Questions	Responses
1		TX RX
1.1	Please confirm that ATA is a “Main Site” as indicated on table 3, page 146 of the Volume 2 specification and not a “Remote Site” as indicated in table 2, page 19 of same specification.	ATA is unique site actually and is more of a main site without the redundancy part as per Table-3. The same equipment for a 'main site' is still required.

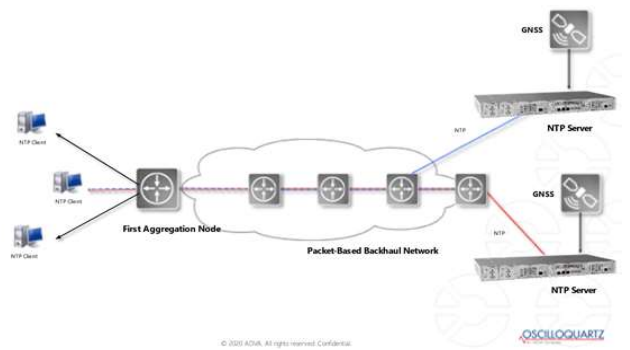
1.2	Figure 2 on page 27 of Volume 2 is not as clear as Figure 3 (pg. 28) and Figure 4 (pg. 29). The labels and equipment descriptions (naming) are unreadable. Please provide a readable diagram on a single substitution page.	See attached diagram for a readable figure.
